Our Case Number: ABP-317780-23
Planning Authority Reference Number:
Your Reference: Eoin Conway and Helen Clarke

Re: Bray to City Centre Core Bus Corridor Scheme Compulsory Purchase Order 2023
Bray to Dublin City Centre

RE: SUBMISSION TO AN BORD PLEANALA IN RESPECT OF SECTION 51(2) APPLICATION BY THE NATIONAL TRANSPORT AUTHORITY FOR THE CONSTRUCTION OF THE BRAY TO CITY CENTRE CORE BUS CORRIDOR SCHEME

Bord Pleanála Case Reference: HA27.317742

Figure 2: Extract from General Arrangement Sheet 50 (Approximate site boundary outlined in navy). Source: NTA, 2023.

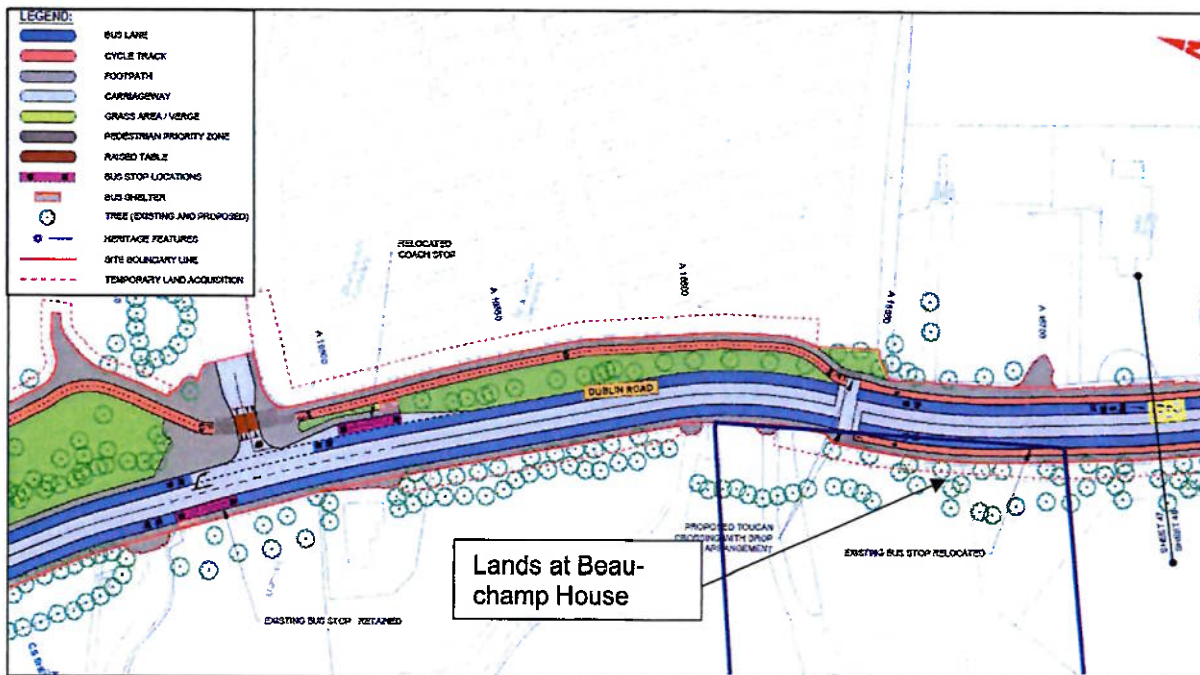
Extracts of the 'General Arrangement Drawings' Sheet 50 (Figure 2 above) set out high level details of the route proximate to Beauchamp House and associated lands. The alignment of

the BusConnects route appears primarily as previously identified by the NTA in public consultation (November 2020).

From Crinken Lane to the Wilford Roundabout it is proposed to provide northbound and southbound bus lanes, segregated cycle tracks and general traffic lanes. Signal-controlled bus priority will be used northbound from Wilford Junction for a short distance as far as Woodbrook College.

Figure 4: Extracts from Sheet 6 and Sheet 7 of Lands to be Compulsorily Acquired Deposit Map (approximate site boundary shown in blue). Source: NTA, 2023.

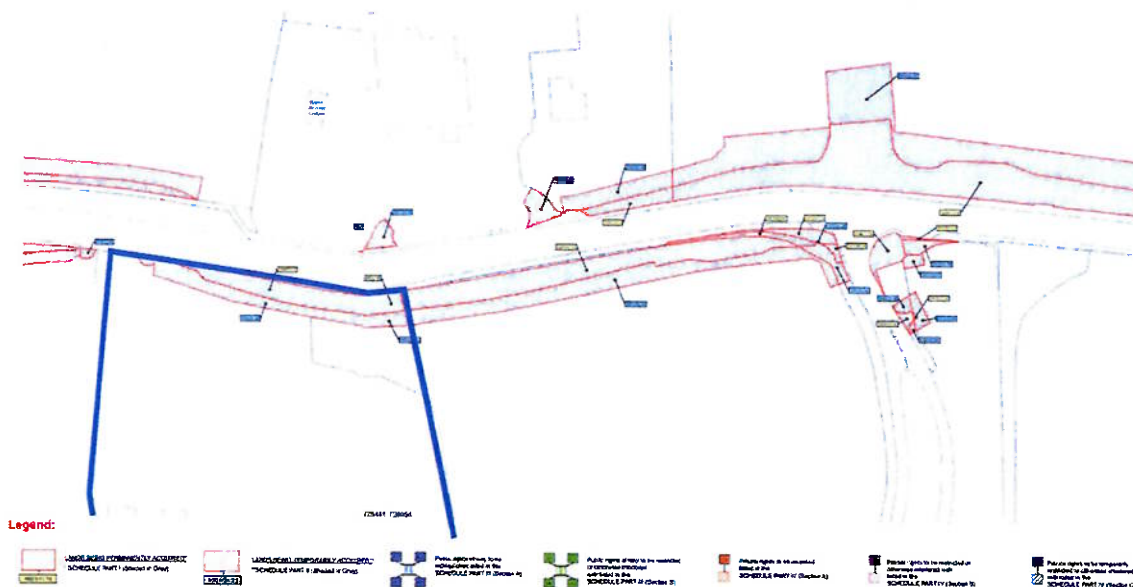
Temporary and permanent land acquisition is identified for Beauchamp House and visible by the redlines in Figure 4 below.

The proposed land take to accommodate a bus and cycle lane on the west side of the Dublin Road will directly impact on the 19th century coursed granite rubble demesne wall

It is considered that the removal of the historic boundary wall to the front of the property will have a negative impact on the setting of the protected structure and will have significantly alter the streetscape along the Dublin Road.

Figure 5: Extract from Tree Removal Plan (approximate site boundary shown in blue). Source: NTA, 2023.

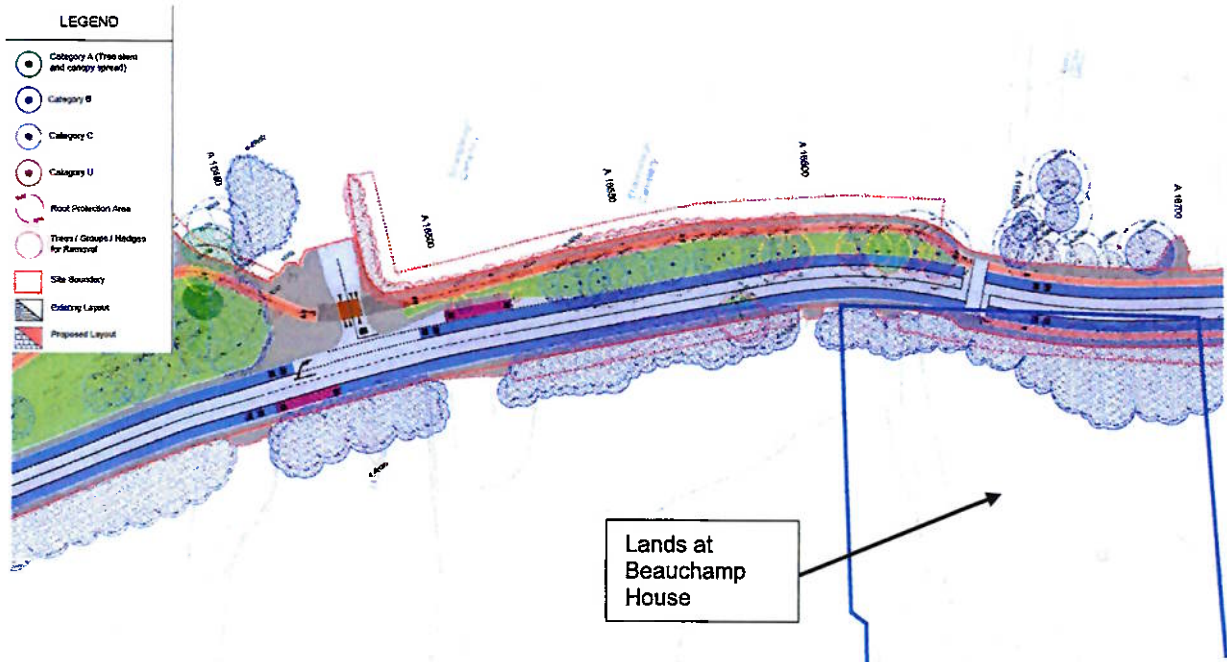
Application). We have included extracts from Tree Removal Plan (see Figure 5) with tree /hedges to be removed highlighted by solid redline. The tree removal plan shows that part of a tree group along the road frontage of the property are to be removed.

It is unclear how many trees along the front boundary of the property are proposed to be removed. While it is noted that a ‘Tree Removal Plan’ has been submitted, the trees on our clients’ lands have not been individually surveyed, instead they have been classed as a tree ‘Group’. The submission sets out the following in relation to recommendations regarding tree removal on the site *“Remove c.1911m² to facilitate proposal and replace as good arboricultural practice”*. Only 7 no. trees are being proposed to replace the partial loss of a significant group of trees, which includes a number of mature trees. This is not considered to be an adequate

In the event that An Bord Pleanála decides to approve the application, we respectfully ask the Board to request modifications to avoid the removal of trees and the front boundary wall at Beauchamp House.

Figure 6: Extract from Landscaping Proposals Sheet 50 (approximate site boundary shown in blue). Source: NTA, 2023.

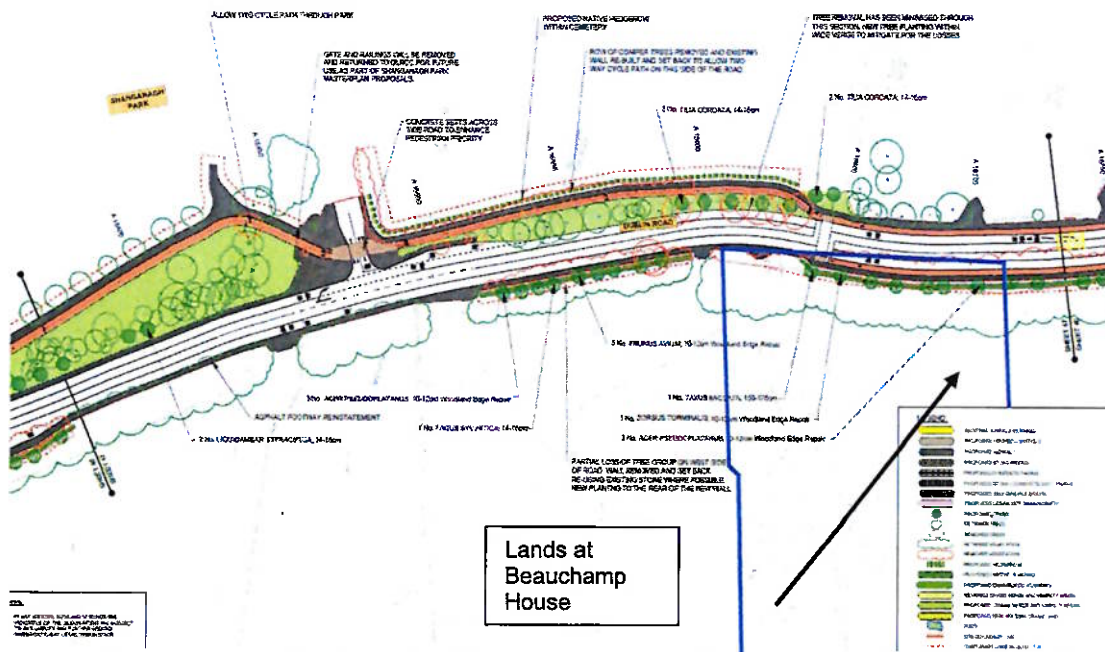
The landscaping drawings details sets out trees proposed to be removed along the boundary with Beauchamp House. Annotation on the drawing states that ‘partial loss of tree group on west side of road. Wall removed and set back re-using existing stone where possible. New planting to the rear of the new wall ‘

Figures 6 illustrates the extent of landscaping proposals with the consequent loss of trees also identified.

Figure 8: Extract from photomontage View 8 existing looking north (Source: NTA, 2023).

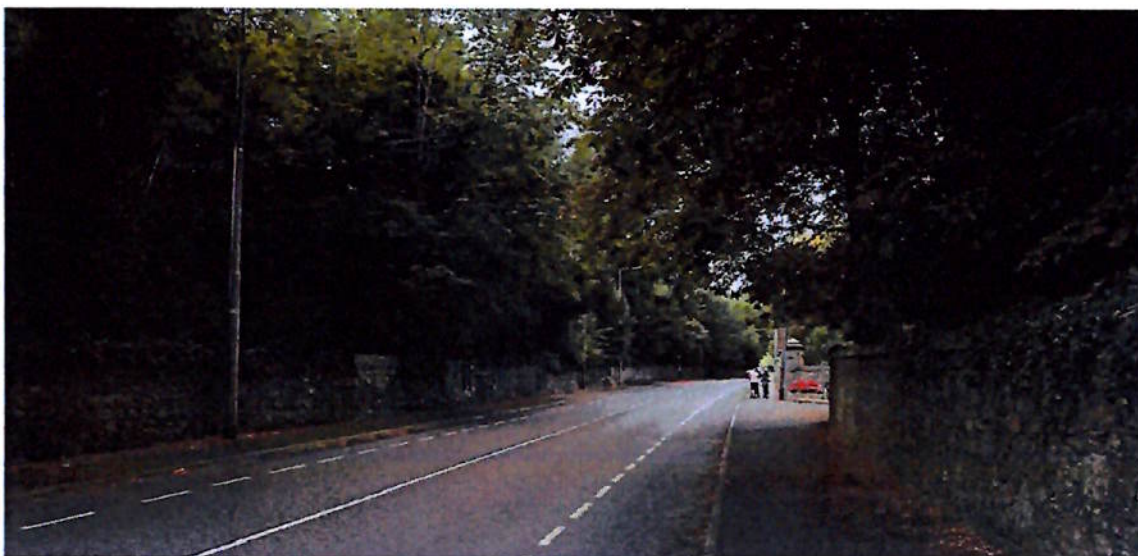
With regard to view 08/09 the EIAR states:

*“Figures 17.2.8.2 and 17.2.9.2 show the proposed view from Dublin Road in the vicinity of St James’ (Cricken) Church. The primary changes in the views are the widening of the road corridor to accommodate bus and cycle lanes, with land take from adjacent properties and a setting back and reinstatement in a like-for-like style of boundary walls. **There is substantial loss of existing mature trees along this section**, however, there is a considerable number of new trees proposed which will increasingly integrate the proposals into the landscape over the long-term. The boundary of the church is not impacted. **There is a negative change to both the views in this section**” (JSA emphasis added).*

As is clear from the above text and the accompanying photomontages, the EIAR has identified significant change and negative impact along the Dublin Road including the widening of the road with removal of a number of historic boundary walls and a section of mature woodland within a sylvan area.

Further, it is not clear if the planting shown in the views will appear as visualised or over a certain time i.e. after a 10-year period. Therefore, we respectfully request that further

information is submit by the applicant regarding this point. It is suggested that the photomontages of the streetscape provide a time lapse showing the planting over a number of years i.e. Year 1, Year 5 and Year 10, so that the short and medium term impacts can be properly assessed.

Figure 1: Extract from General Arrangement Sheet 50 (Source: NTA, 2023) red boxes highlight alterations from previous scheme.

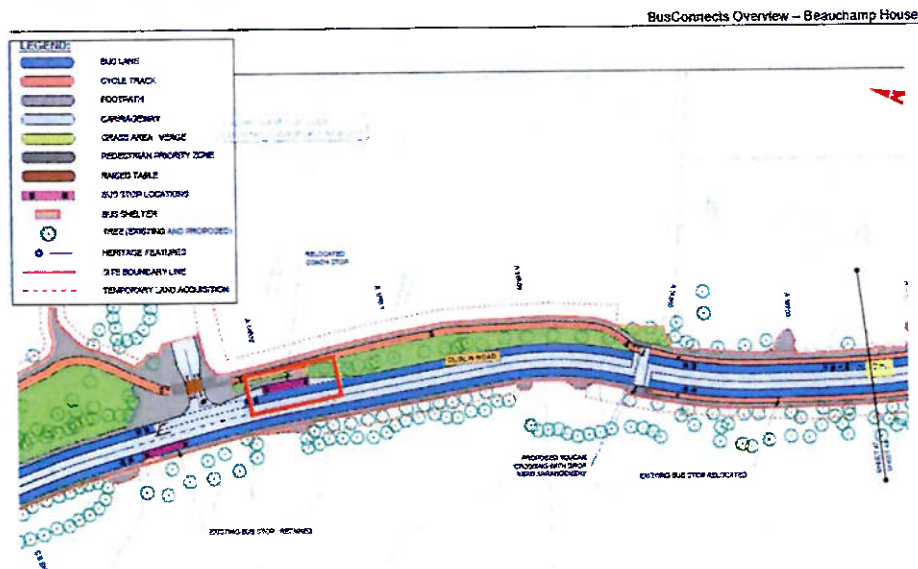
Figure 1 above gives the impression only 6 or 7 trees will be affected by the proposed works. This is very misleading. The impacted area is a long-established woodland, possibly ancient, which has evolved to be so much more than the sum of all its parts. It is a thriving, self-sustaining, naturally regenerating woodland, with very well-developed species, age, height, and habitat diversity. This woodland would not survive the removal of its entire eastern boundary.

The impact of any tree removal at Beauchamp House would go well beyond the small area marked in red and its 6 or 7 trees. Removing the entire eastern boundary would affect hundreds of stems, each an individual tree. Over 70 trees were recorded with diameters over 15cm dbh (diameter breast height), but it is important to note that many of the species
